Access Compliance Report

Public Rights-of-Way

(Curb Ramps)

Intersection ID: 10029671	Main Street: KINGS_RIDGE_DR	Cross Street: N/A	Location: NE
ADA ID: F7070D8B58D0	Ramp Type: PerpDiag	Initial Pass/Fail: Fail	Overall Compliance: No
Severity Score: 37.5			
Codes/Mitigation Info/Possible Solution		Field Measurements/Component Compliance

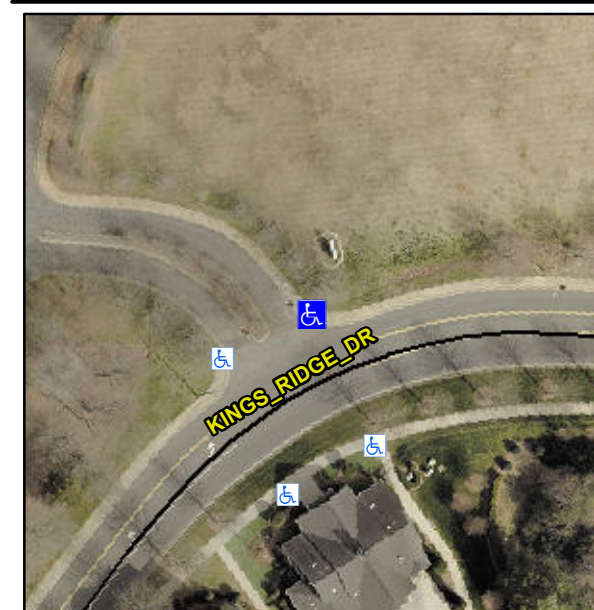
Not Found, R304.2.2, R304.5.3

Compliance	Description	Data	Compliance	Description	Data
N/A	Ramp Length (in)	58.0	No	Ramp Slope (%)	8.9
Yes	Ramp Width (in)	48.0	No	Ramp XSlope (%)	10.6
N/A	Flare Type LT	N/A	N/A	Flare Type RT	N/A
N/A	Flare Slope LT (%)	N/A	N/A	Flare Slope RT (%)	N/A
N/A	Flare Traversable LT?	N/A	N/A	Flare Traversable RT?	N/A
N/A	Landing Length (in)	N/A	N/A	DWS Provided?	N/A
N/A	Landing Width (in)	N/A	N/A	DWS Contrast?	N/A
N/A	Landing Slope (%)	N/A	N/A	DWS Length (in)	N/A
N/A	Landing X Slope (%)	N/A	N/A	DWS Full Width?	N/A
N/A	Landing Curb? (Y/N)	N/A	N/A	DWS Offset (in)	N/A
N/A	Shared Landing?	N/A			
N/A	Gutter Ponding?	N/A	N/A	Gutter Slope (%)	N/A
N/A	Gutter Lip Ht (in)	N/A	N/A	Gutter X Slope (%)	N/A
N/A	Painted X Walk1?	No	N/A	Painted X Walk2?	No
	X Walk 1 Direction	To W		X Walk 2 Direction	To S
N/A	X Walk 1 Width (in)	N/A	N/A	X Walk 2 Width (in)	N/A
	X Walk 1 Slope (%)	6.5		X Walk 2 Slope (%)	8.2
	X Walk 1 X Slope (%)	5.3		X Walk 2 X Slope (%)	5.6

Remove & Replace Curb Ramp With Two New Directional Ramps or Equivalent.
